## D/DRC Case

550 Assembly Street and 507-19 Main Street

**DESIGN/DEVELOPMENT REVIEW COMMISSION  
DESIGN REVIEW DISTRICT  
CITY CENTER/HISTORIC AGENDA  
EVALUATION SHEET  
Case # 4**

**NATURE OF REQUEST:** New Construction and Site Improvements

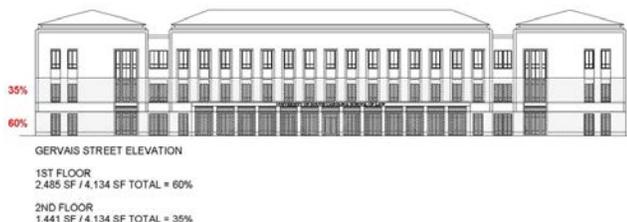
As proposed based upon staff calculations the following has been proposed.

- Assembly Street Upper Floors = 41% \* 1% more than recommended.
- Blossom Street Upper Floors = 43% \* 3% more than recommended.
- Assembly Street Lower Floors = 33% \* 37% less than recommended.
- Blossom Street Lower Floor = 37% \* 33% less than recommended.

With the option noted in 5.3.2 above the lower floors could result in window areas of 42% for Assembly Street and 45% for Blossom Street. Staff recommends that both street facades get closer to 45-60%, this is an item that can be deferred to staff.

SHEET TITLE:  
**LANDSCAPE PLAN**

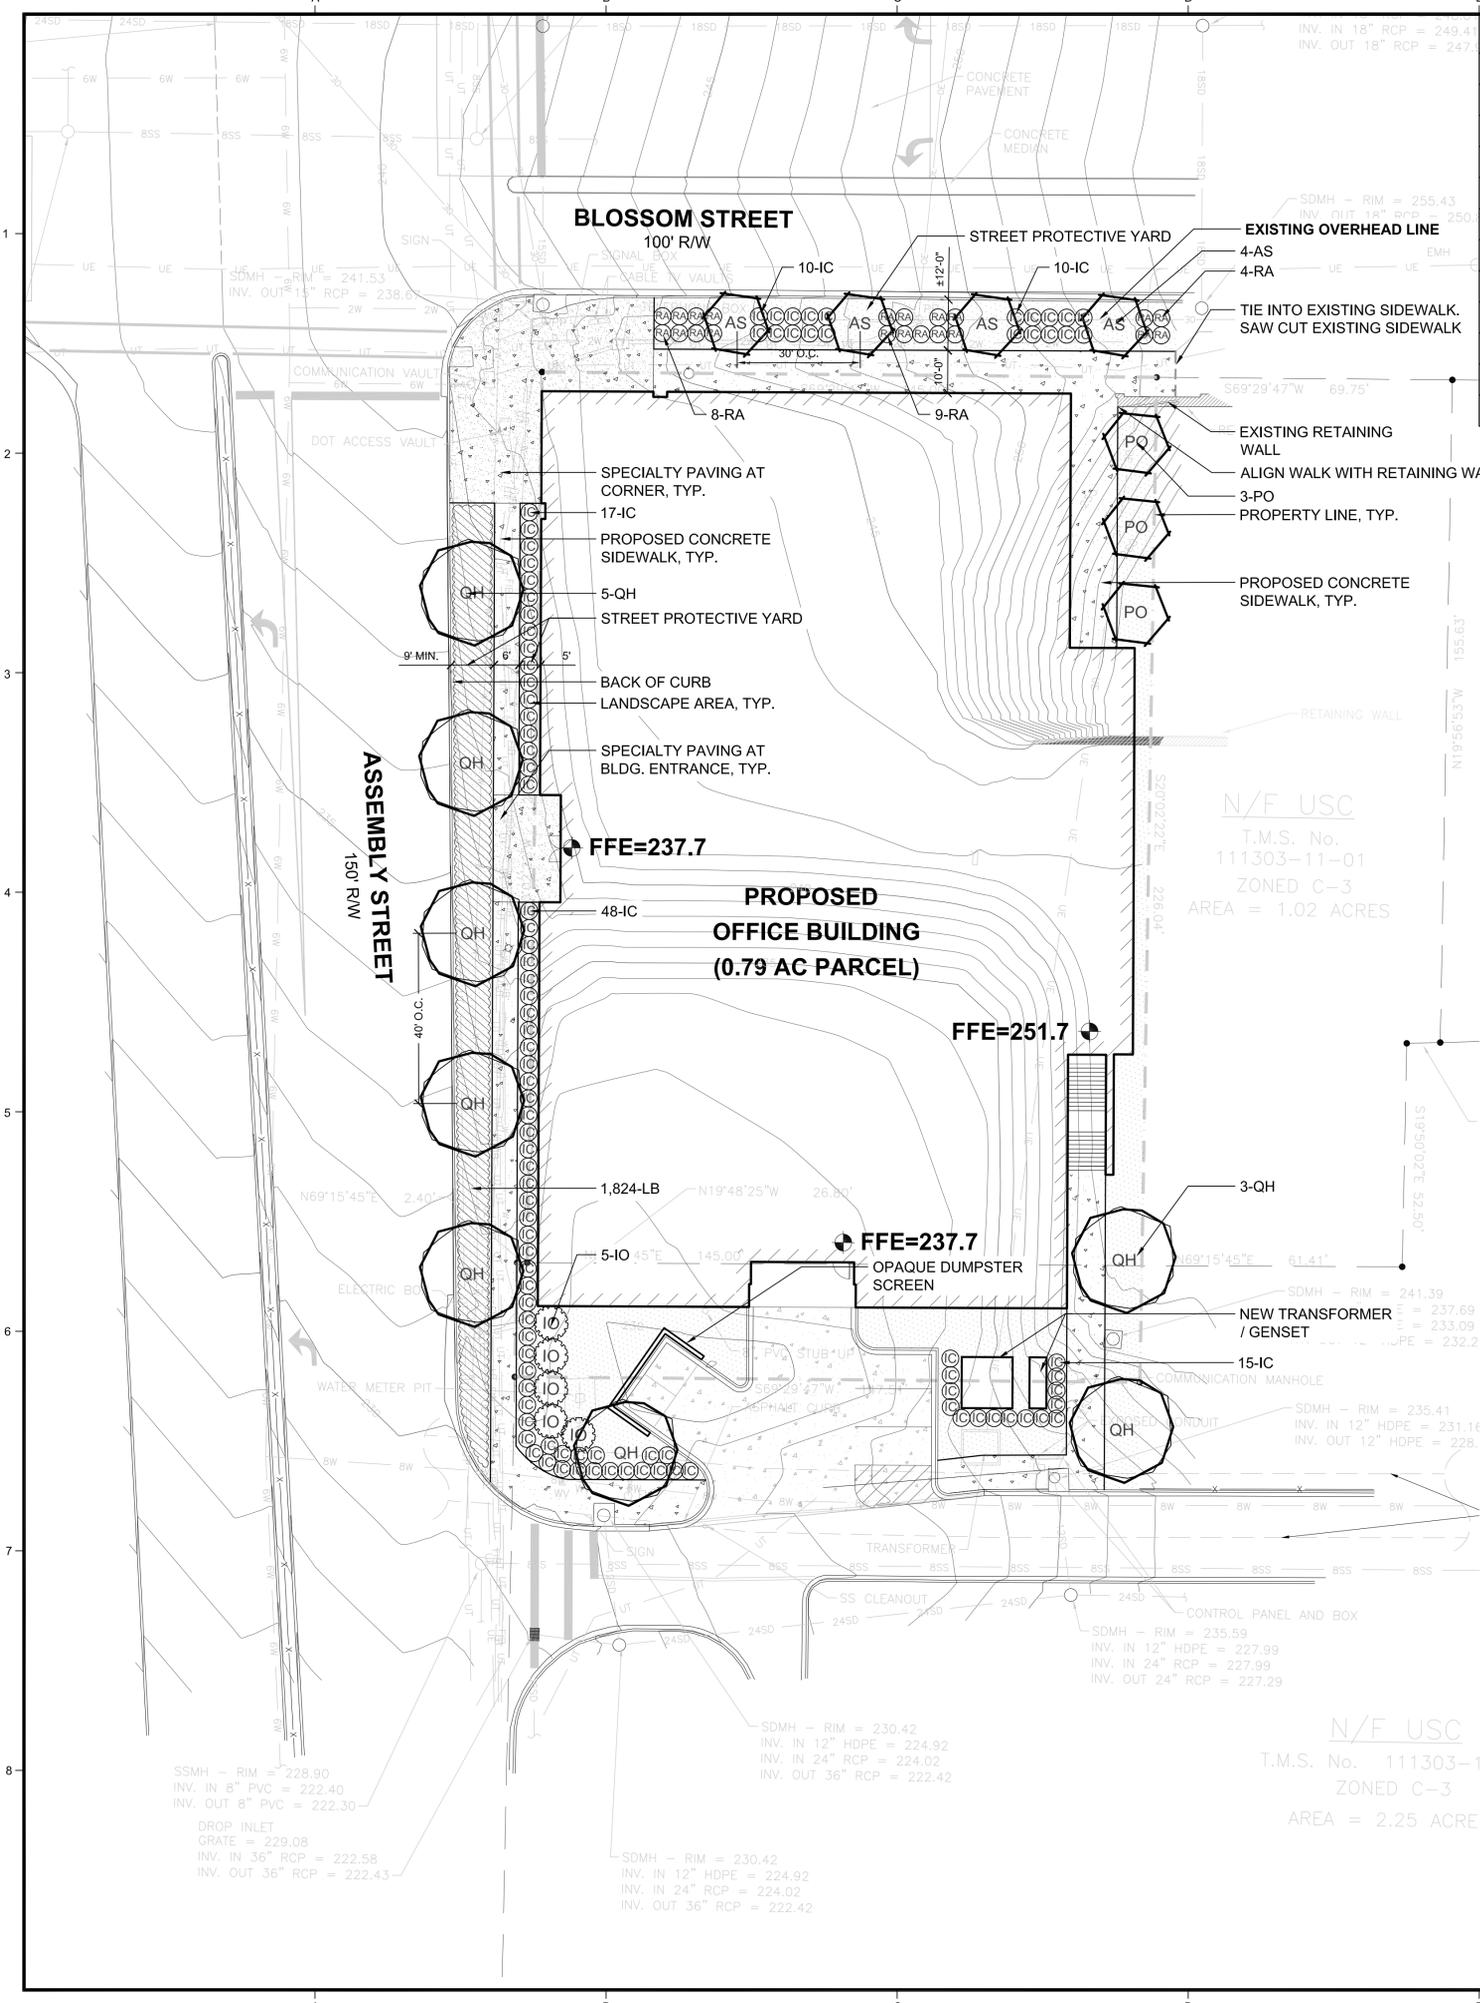
General landscaping plans have been provided. Staff recommends landscaping plans be deferred to staff.
